FORWARDING LIC NO DPR-49 APPL FOR AMEND: APPENDIX B TECH SPEC PROPOSED CHANGE
CONCERNING REVISION TO THE ENVIRON SURVEILLANCE AND SPECIAL STUDIES AT
SUBJECT FACILITY... NOTARIZED 07/24/78... W/ATT LIC FEES.

PLANT NAME: DUANE ARNOLD

Transmitted herewith, in accordance with the requirements of 10 CFR 50.59 and 50.90, is an application for amendment of DPR-49 (Appendix B to License) for the Duane Arnold Energy Center.

PROPOSED CHANGE ETS-26 TO DAEC TECHNICAL SPECIFICATIONS

FIGURE 4.3-1 RADIOLOGICAL ENVIRONMENTAL MONITORING PROGRAM SAMPLING STATION

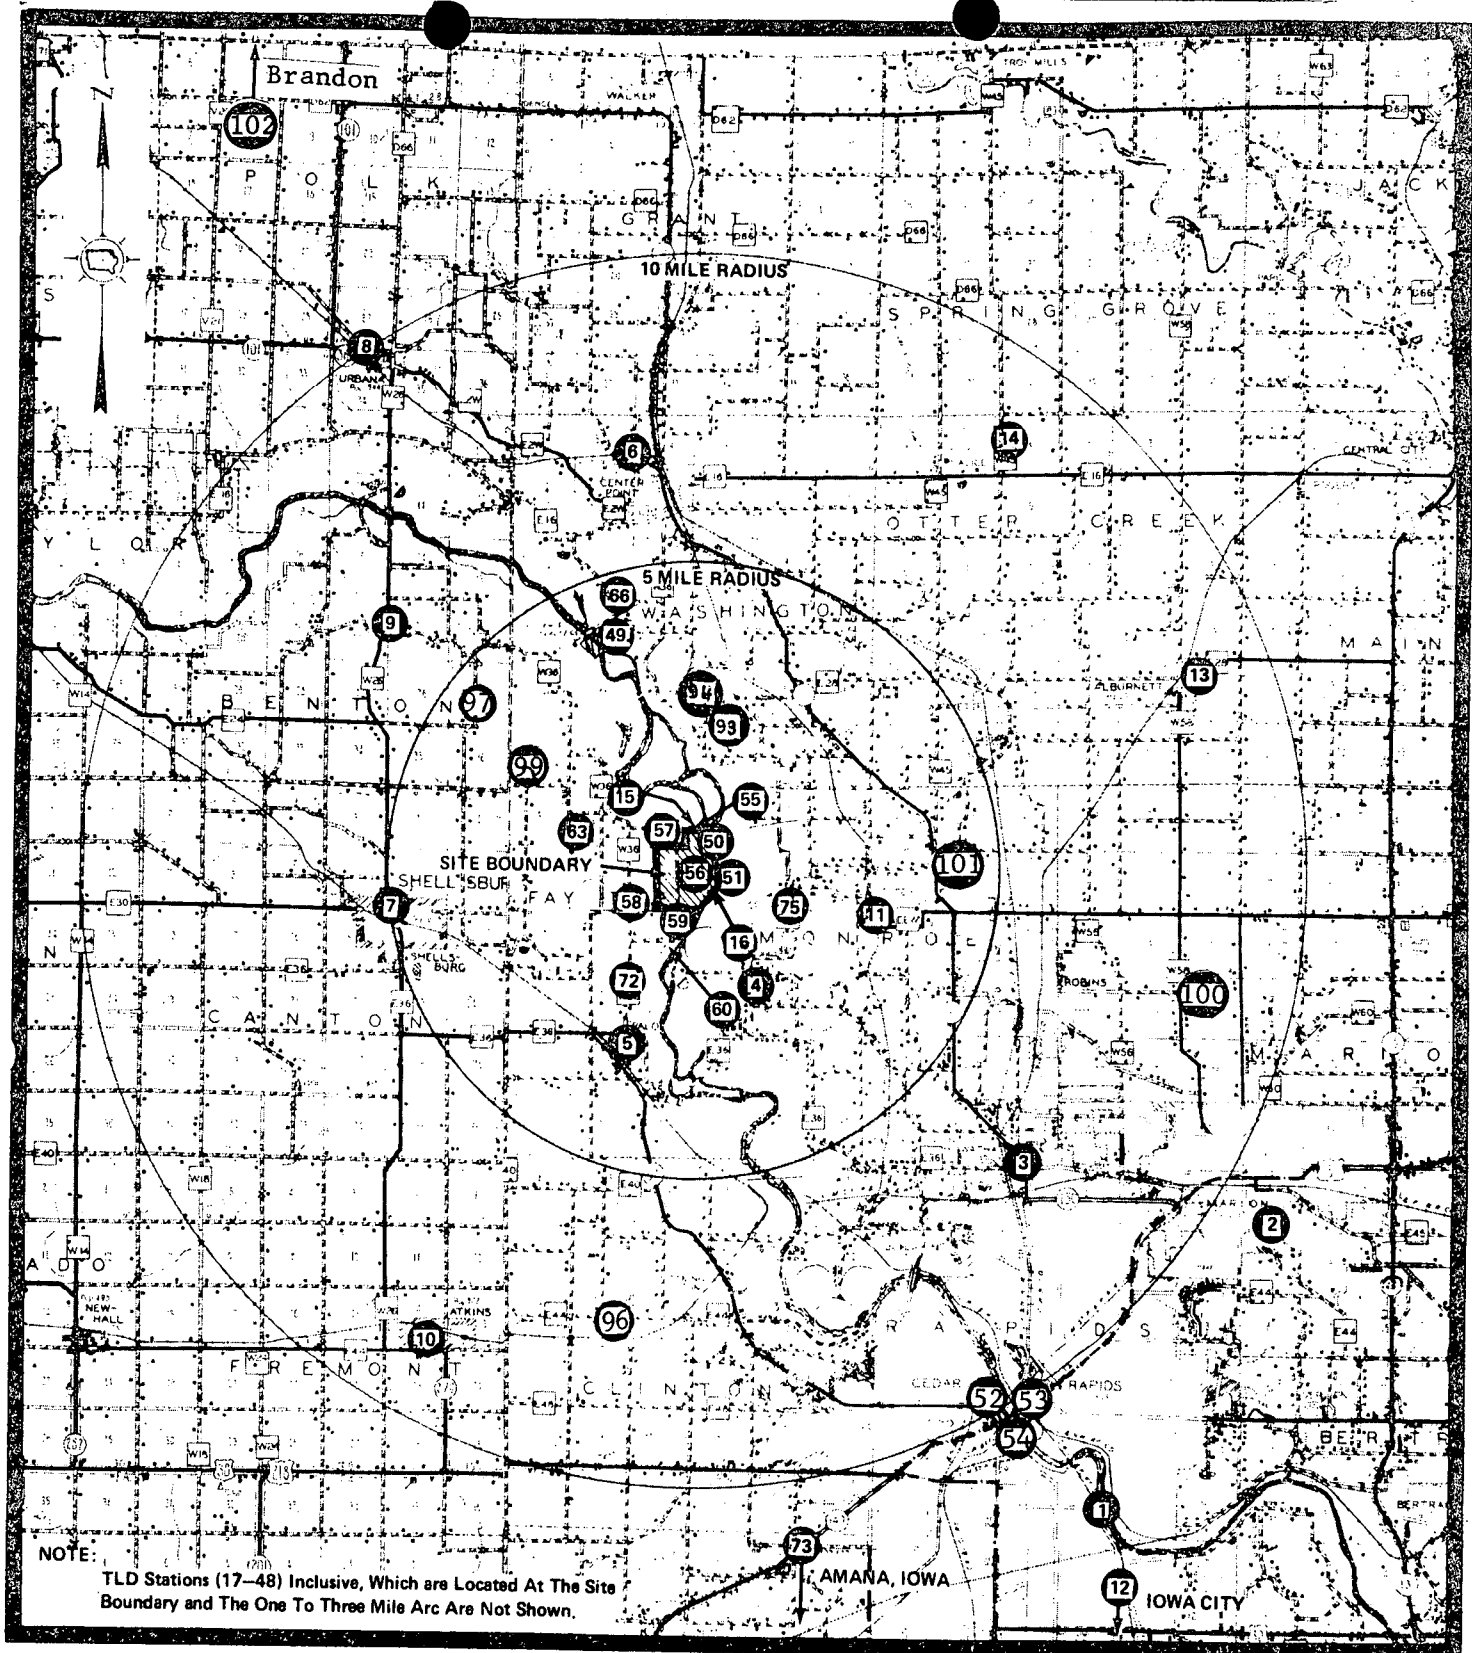
Delete sheets 4.1-1 through 4.1-3, 4.3-1 through 4.3-11, and 4.3-13 and replace with the attached sheets.

The subject Technical Specification change is proposed in order to correct radiological sampling locations, frequency of samplings, and to clarify the procedure to be used if samples are not obtainable.

- A. Environmental samples shall be collected and analyzed according to Table 4.3-1.
- B. Sample locations are as shown in Figure 4.3-1. Any location from which milk, soil, and vegetation samples can no longer be obtained may be dropped from the surveillance program after notifying the NRC* in writing.
